SECQ and its sensitivity to measurement bandwidth

zivny_3cd_01c_0518
Pittsburgh, PA

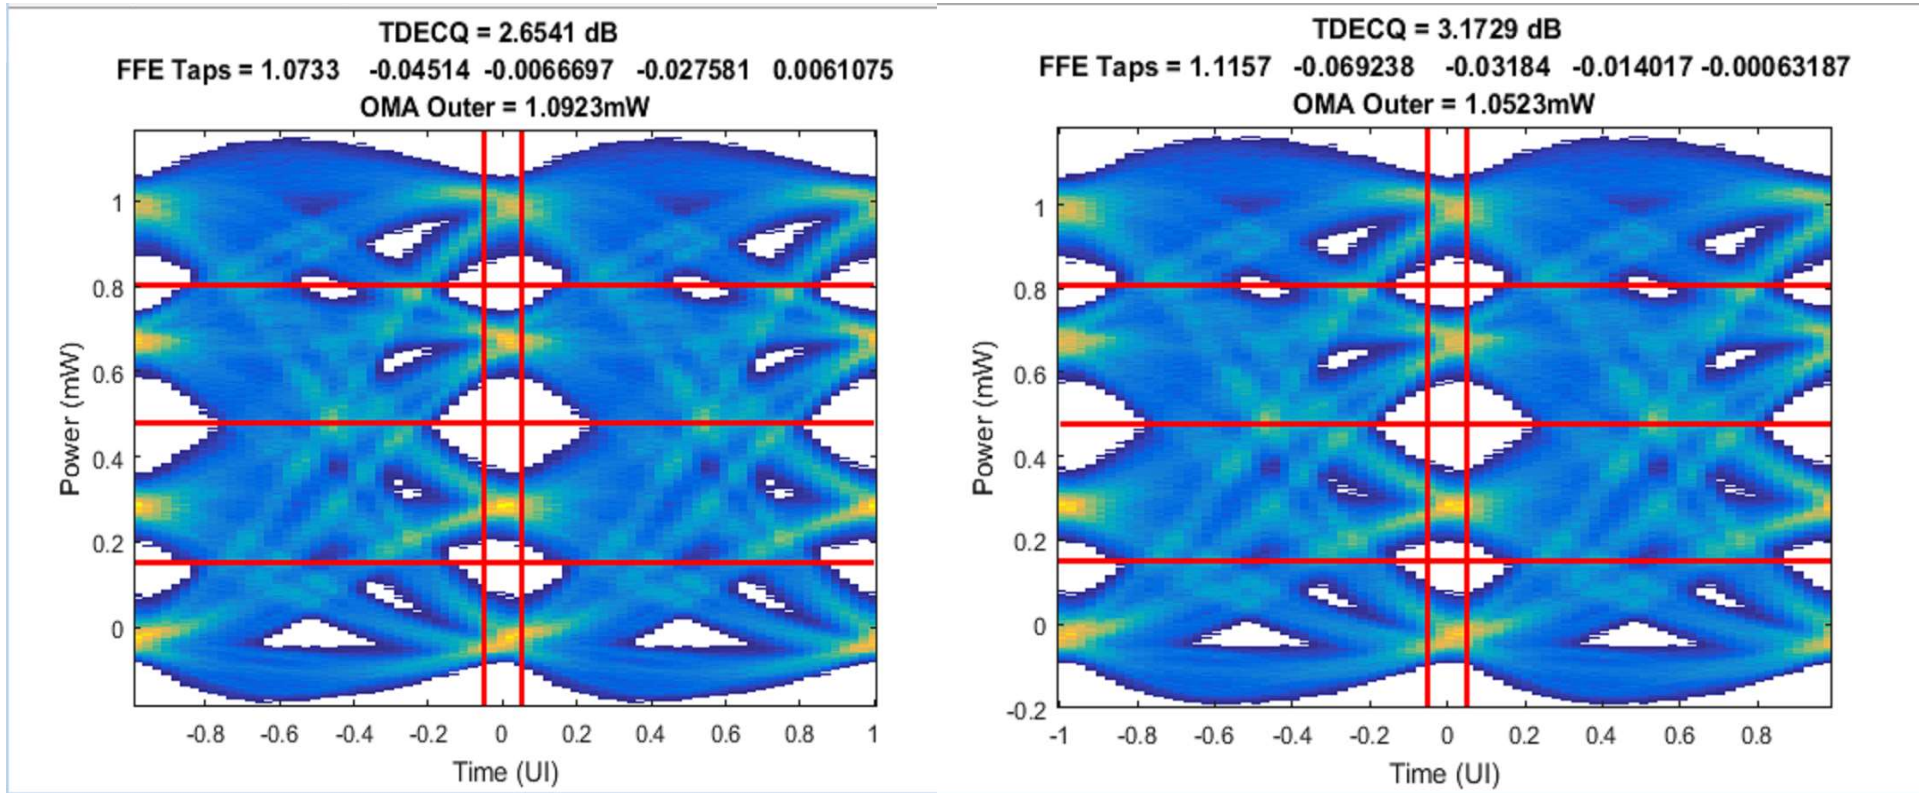
- In the following the problem is demonstrated by capturing a clean 26.56 GBd signal with an oscilloscope with same bandwidth, but two different roll-offs.

SMALL DECREASE OF ROLL-OFF FREQUENCY INCREASES THE MEASURED SECQ.

- 18 GHz roll-off of the B-T:
SECQ=2.65 dB
- 17.2 GHz roll-off of the B-T:
SECQ=3.17 dB

- As shown in previous slide, a small change of roll-off bandwidth from 18 GHz to 17.2 GHz added 0.51 dB of penalty to SECQ. (This all with a soft roll-off).
- That is, the same receiver measured with the 2nd signal will show 0.5 dB higher sensitivity.
- This example can be carried further; the point is, an earnest implementer can follow the standard to a 't', yet under-stress their receivers, and pass bad products.

“The SECQ of the stressed receiver conformance test signal is measured according to 138.8.5, except that the combination of the O/E and the oscilloscope has a bandwidth of approximately 13.28125 GHz and a fourth-order Bessel-Thomson filter response to no less than $0.9 * 26.5625$ GHz. The optical splitter and variable reflector shown in Figure 121–4 are not used.”
